This Addendum shall be considered part of the bid documents for the above-mentioned project as though it had been issued at the same time and shall be incorporated integrally therewith. Where provisions of the following supplementary data differ from those of the original bid documents. This Addendum shall govern and take precedence. ***Bidders Must acknowledge this addendum on their bids.***

UTAH STATE UNIVERSITY

VET SCIENCE / LARC BUILDING

Re-Roof Project

B1 PARAPET W/ METAL COPING CAP

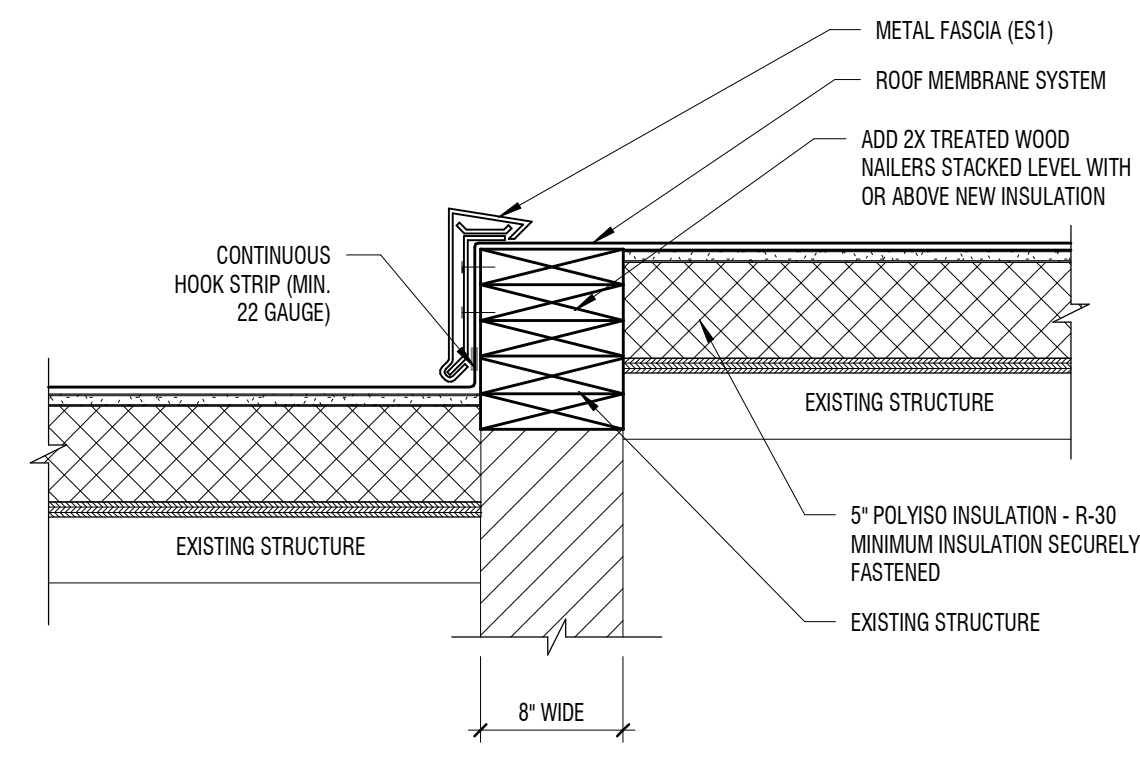
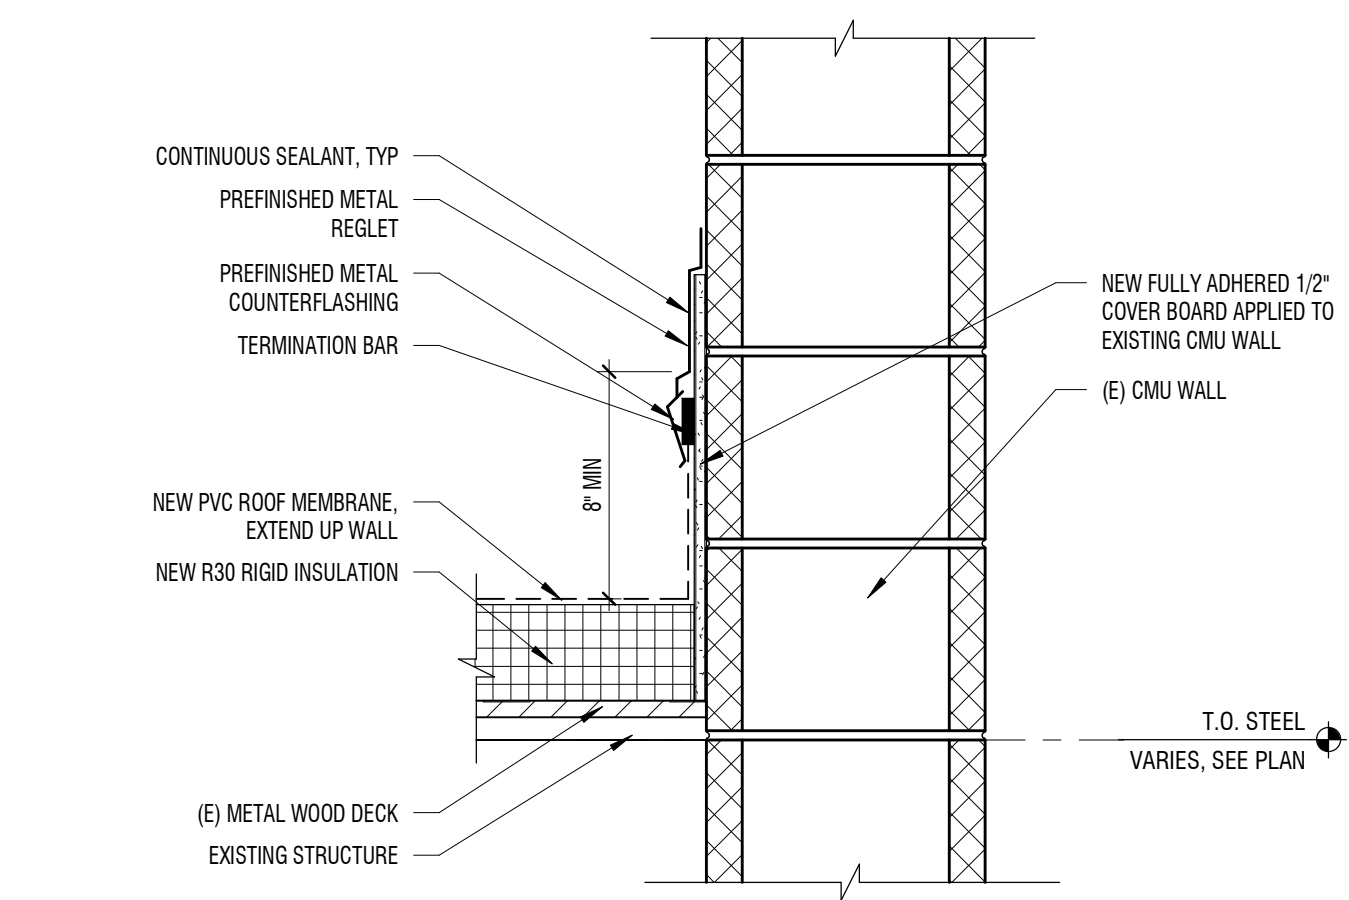
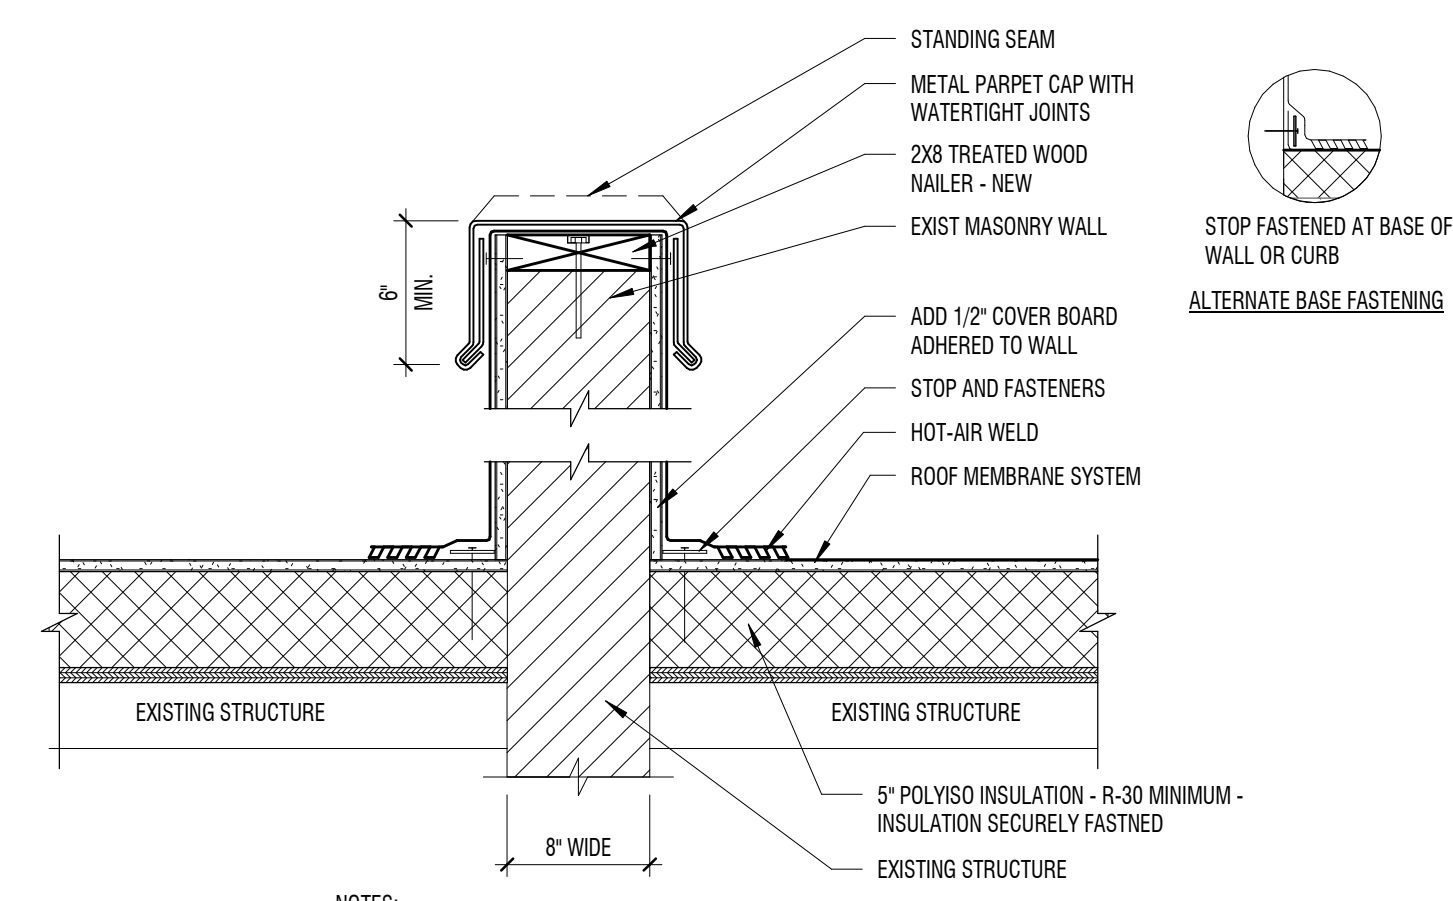
- 01.11 A-505
 - Updated Details B1, B4, C1

A4 SECTION
3/4" = 1'-0" @ ROOF ACCESS LADDER

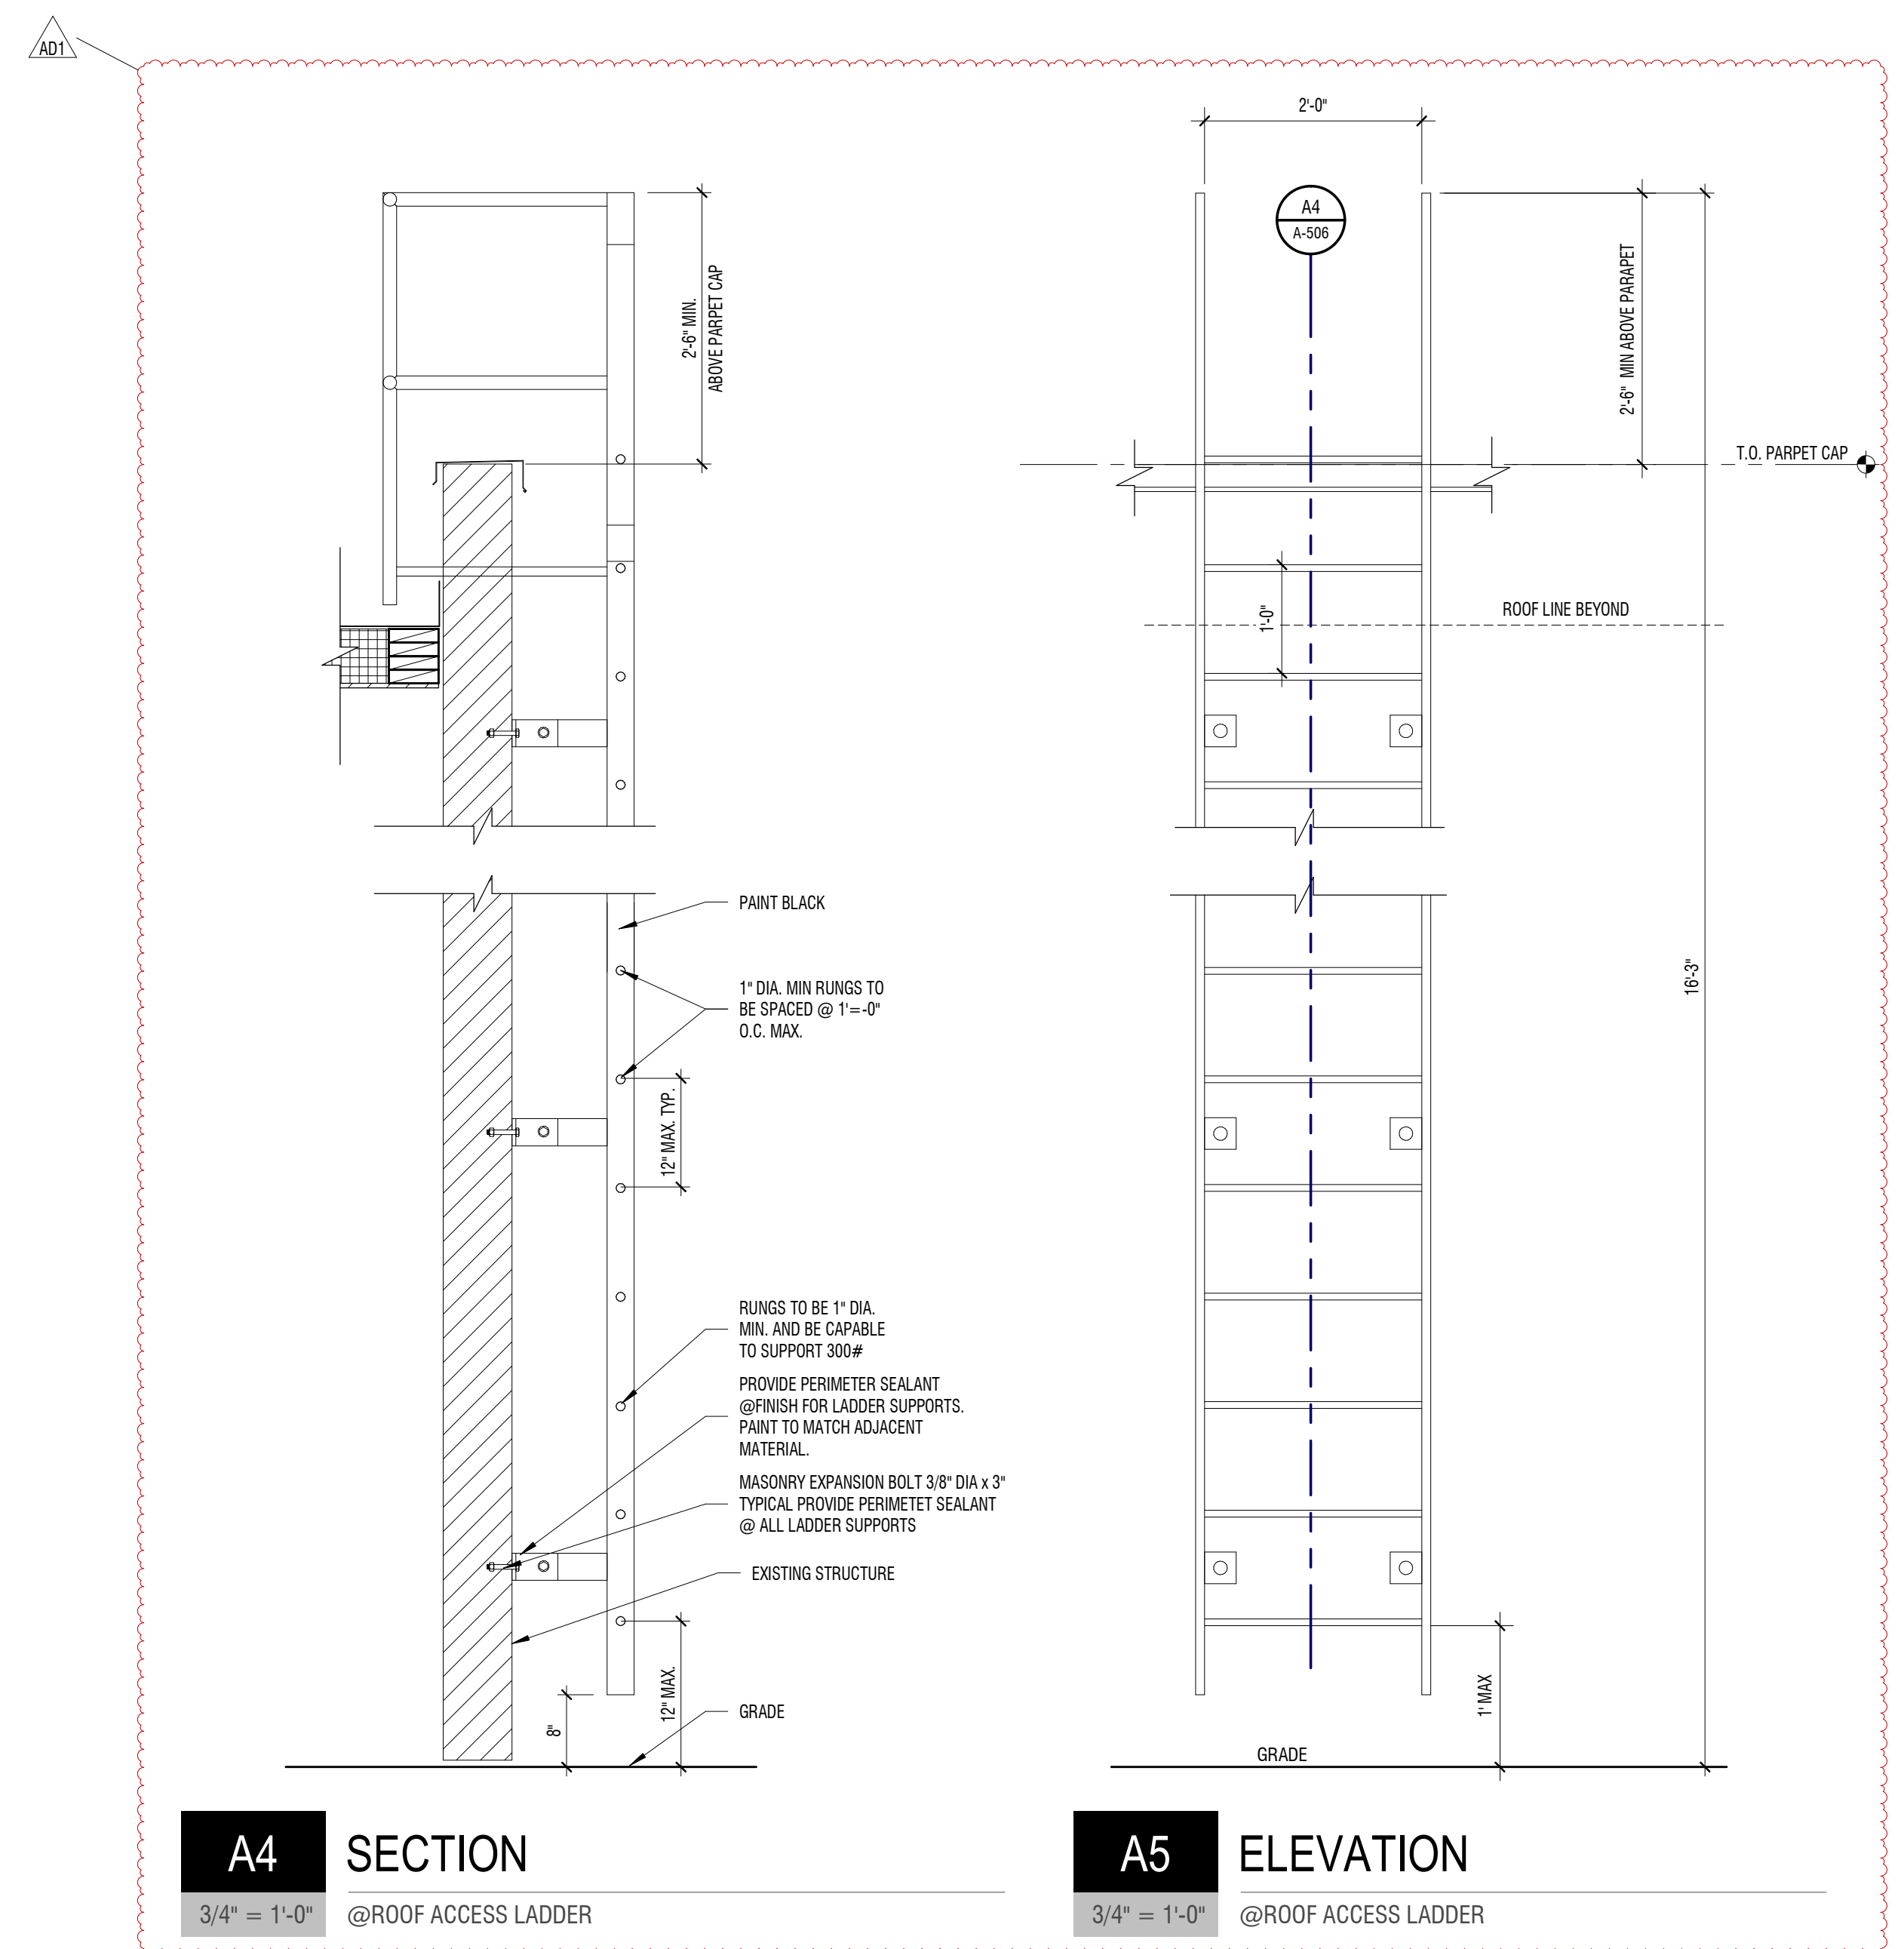
- 01.12 A-506
 - Added sheet with ladder details

03.01	EPOXY REPAIR OF CONCRETE SPALLING. PROVIDE METAL CAP AND FLASHING
05.02	EXTEND DUCT SUPPORT STANDS TO STRUCTURE DECKING
05.03	PROVIDE PRE-FABRICATED ALUMINUM LADDERS OR FABRICATED STEEL LADDER - SEE A-506 FOR DETAILS
